# Site Accessibility Evaluation

## Americans with Disabilities Act Title II (Public Services: State and Local Government)

### County Professional Building

105 E Vermijo Ave  
Downtown, CO 80903

Finding 25852 Main Photo

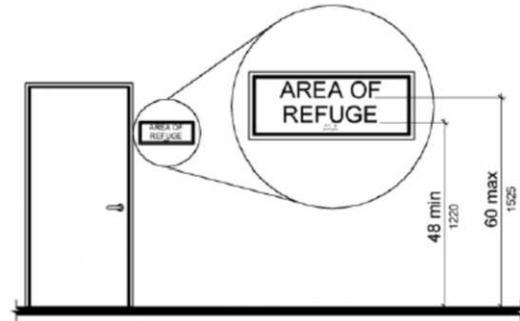
Compliant room identification signs are missing on the strike side of the door.

2010 ADAS Section: 216.2, 703.4.2

No room identification sign

Submit a work order to have sign installed adjacent to front as depicted in photo.

Corrective Action: W/O 381203 submitted. Completed 2/24/2017.

Finding 25855 Main Photo

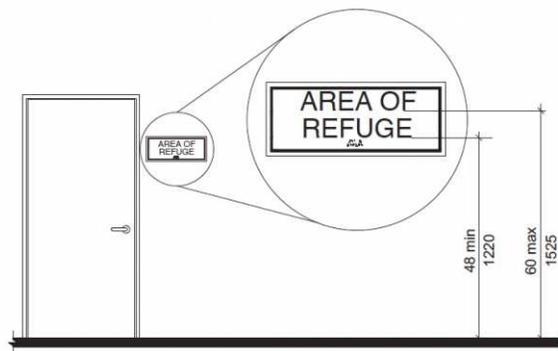
The wall sign is mounted too high.

2010 ADAS Section: 703.4.1

62 inches  
high/character missing

Submit work order to have proper sign installed at proper height.

Corrective Action: W/O 381215 completed 381215.

Finding 25854 Main Photo

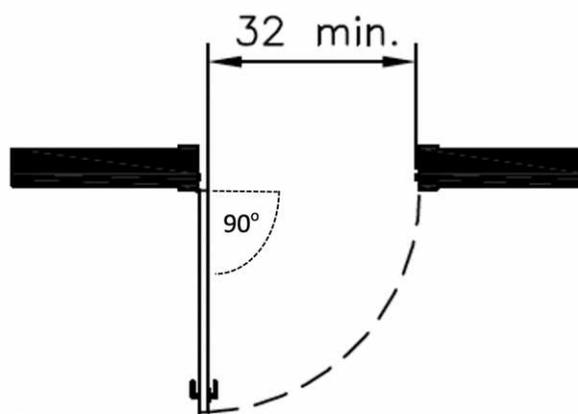
The door opening does not provide at least 32 inches between the face of the door and the opposite stop.

2010 ADAS Section: 404.2.3

Double door, each side  
opens 29 inches

Submit a work order to have doors adjusted/replaced. Bill Dieter spoke w/Kim Short, she said that the public no longer uses this area and that when the public goes through security they are directed to the reception area in room 101 straight down the hall.

Corrective Action: W/O 381260 submitted. Corrective Action no longer needed due to process change.

Finding 25857 Main Photo

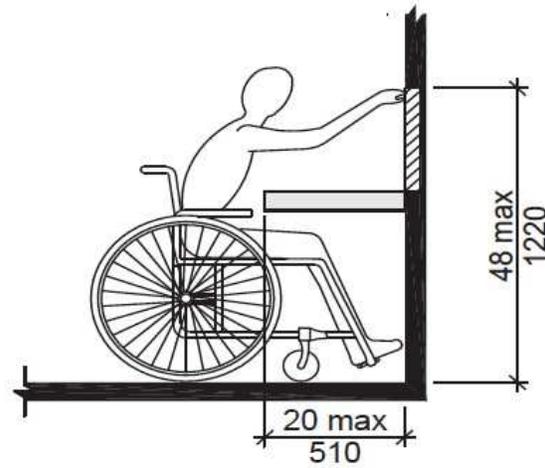
The clear floor space only allows for a forward approach and the brochure rack is out of reach range.

2010 ADAS Section: 308.2.2

Brochure rack located behind chair

Lower brochure rack to a maximum reach of 44 inches or move to different location.

Corrective Action: W/O 381214 completed 02/09/2017.

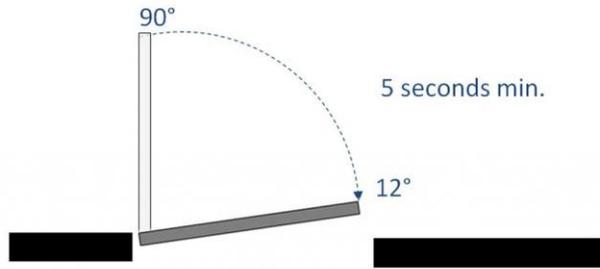
The door is equipped with a door closer and returns to a closed position too quickly.

*2010 ADAS Section 404.2.8.1*
